**Proposed Dwelling Sizes - 114 Herring Road, North Ryde
Concept Plan (MP10_0112) (MOD2) &
Stage 1 Project Approval (MP_0113) (MOD 1)**

TABLE 1 – OBJECTIONS RAISED AND RESPONSE

MP10_0112 & MP10_0113 MODS - Stamford Macquarie Park

CENTRAL OPEN SPACE (1165m² required)  1180m²

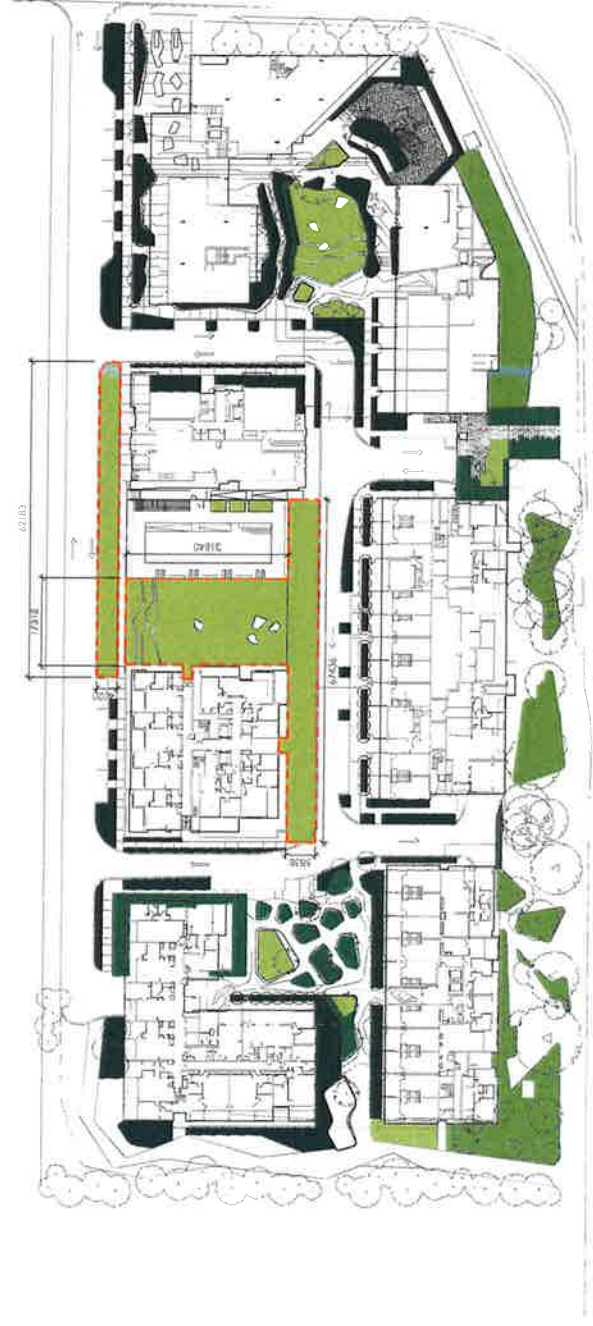
What is the difference in the amount of open space per residents if the approved scheme is compared to the proposed scheme? (City of Ryde Council)

Council's comment is contradictory of it's own Ryde DCP 2010 that requires a minimum 30% of the developable area of the site is to be provided as Landscaped Area within the Macquarie Park corridor, rather than provision of landscaping based on per resident basis.

Furthermore Condition B4 of PAC approval MP10_0112 requires a minimum provision of landscaped open space area within the central park area of 1,665m². The proposed modification does not result in a reduction of the minimum landscaped area required to the central park, other landscaped areas across the site or private courtyards at the ground floor.

The attached open space diagram demonstrates that development achieves the required 1,165m² of open space as per the condition of consent with dimensions included.

THE DARWIN

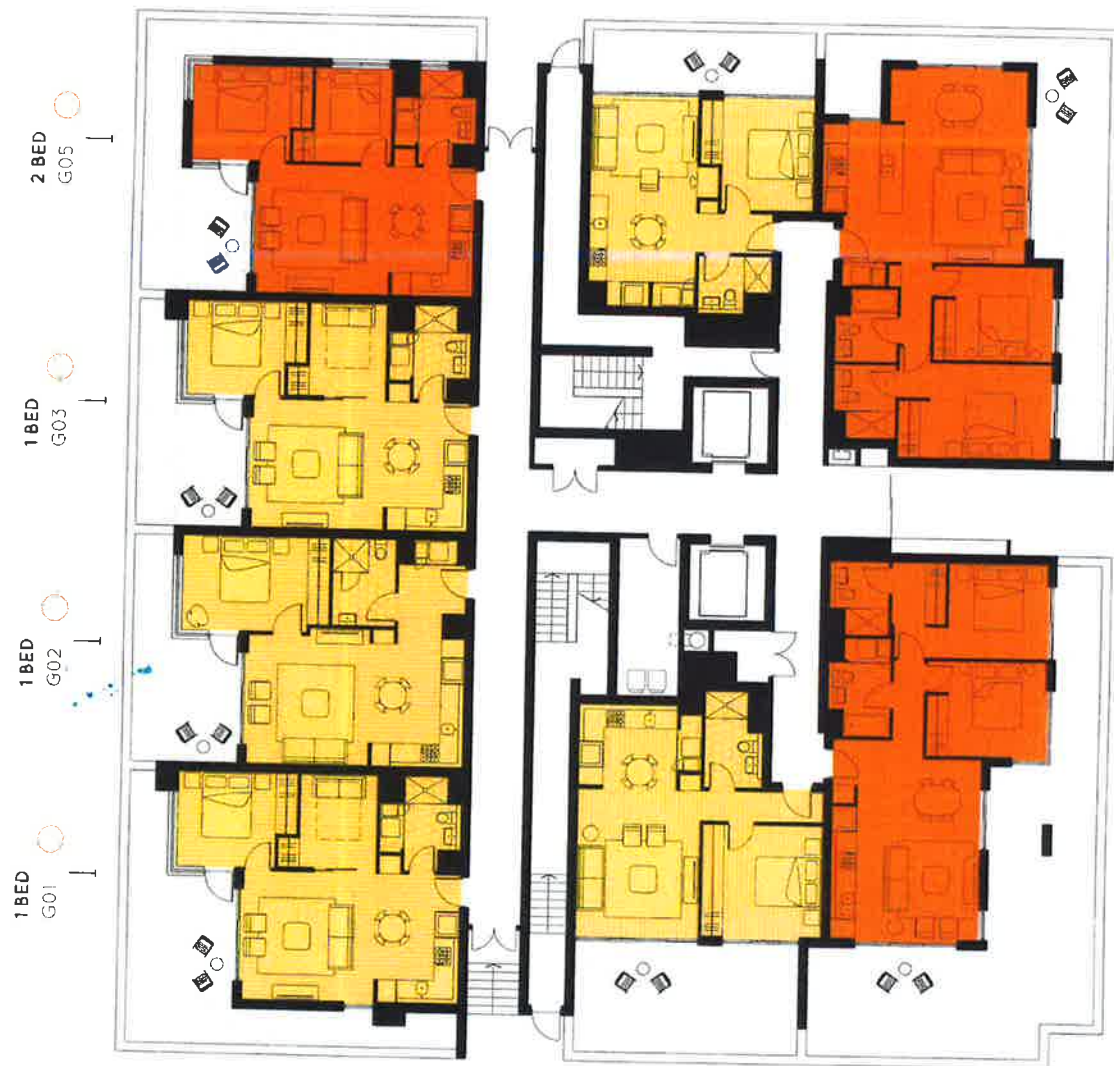
The wording of the commitment is that the dedicated units will be "appropriately sized and located". This provides an opportunity for the DP&I to put some rigour into those words to ensure that the units provided as "affordable" do not only represent the least saleable or most poorly located dwellings within the complex. And should have a minimum of two bedrooms and identification of the units should be made prior to the release of the Construction Certificate for the relevant stage. Handover of units should occur prior to the release of the Construction Certificate for the relevant stage. (City of Ryde Council)

The proponent is providing 2 affordable housing units in Stage 1 of the proposed development. The details of each unit are identified below:

Unit 1 (G09)

Located: Ground Floor of Darwin Building; 1 x bedroom apartment; Internal Area 54m²; External courtyard 25m². SEPP 65 compliant in respect of solar access. 1 x parking space.

The floor plans for each affordable housing unit are attached to identify the proposed detailed layout of each apartment.

BUILDING SYDNEY LEVEL 01 FLOOR PLAN - REVISION 05

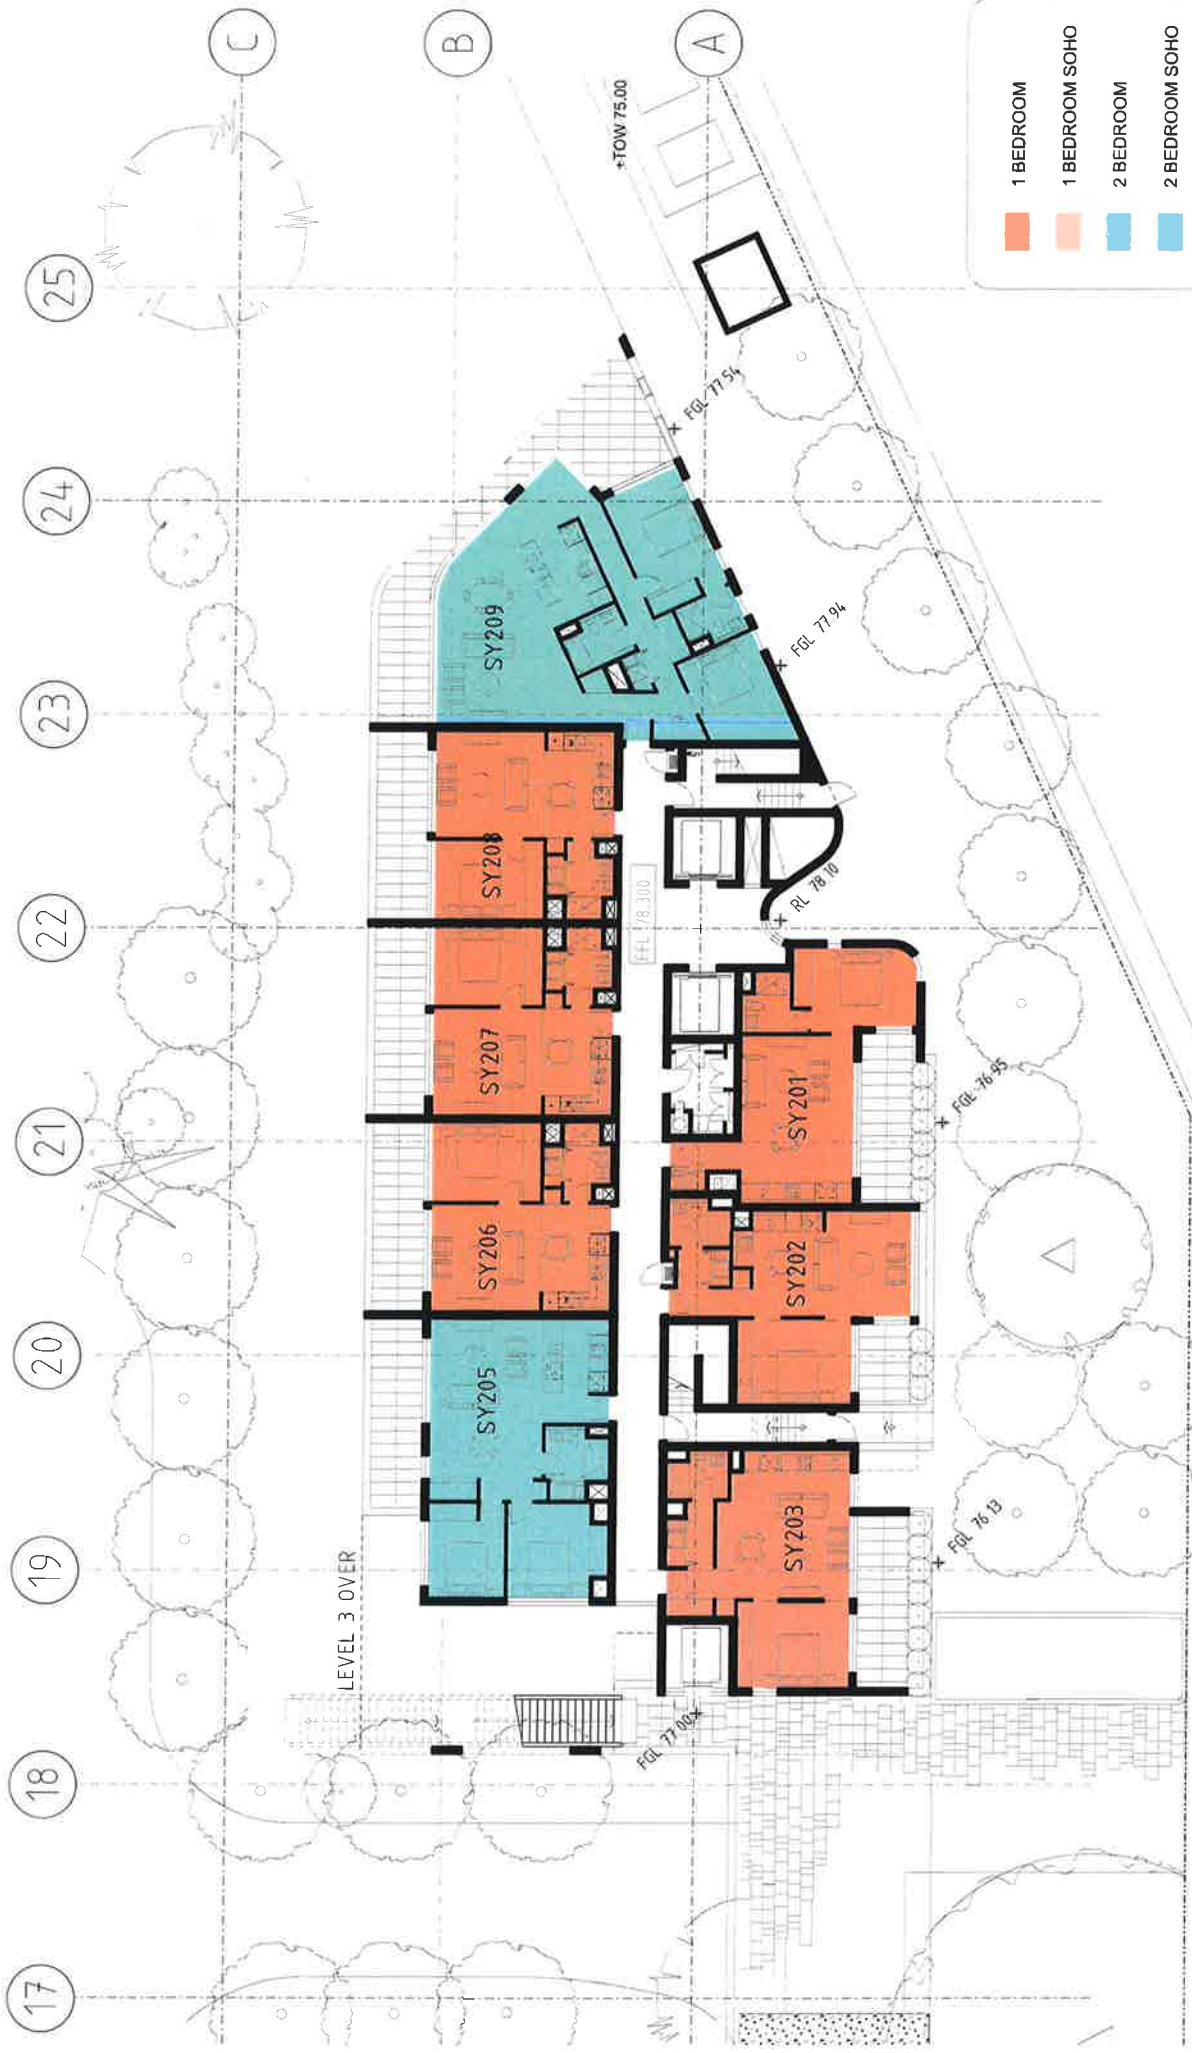
The feedback included:

- that the SOHO apartments within the Sydney building should clearly provide a commercial space at ground level with an apartment over, and
- increase the public stair width.

In order to achieve this, we have amended the plans and reduced the number of SOHO apartments in the Sydney building from 6 apartments to 3. Each SOHO has become much wider and increased in area, with the overall SOHO area footprint remaining about the same. The amended plans also show the amended stair and lift adjacent the Sydney building which were also part of the feedback we received.

Overall FSR remains at 2.28:1. The changes in GFA to the Sydney building at levels 00 and 01 are only minor and will result in an increase of 20m² GFA across levels 00 and 01 with the proposed modification. Notwithstanding the 20m² increase in GFA in the proposed amendments to the Soho apartments, the total GFA will be 51,139 m² as stated in the current modification application as submitted. Furthermore the GFA
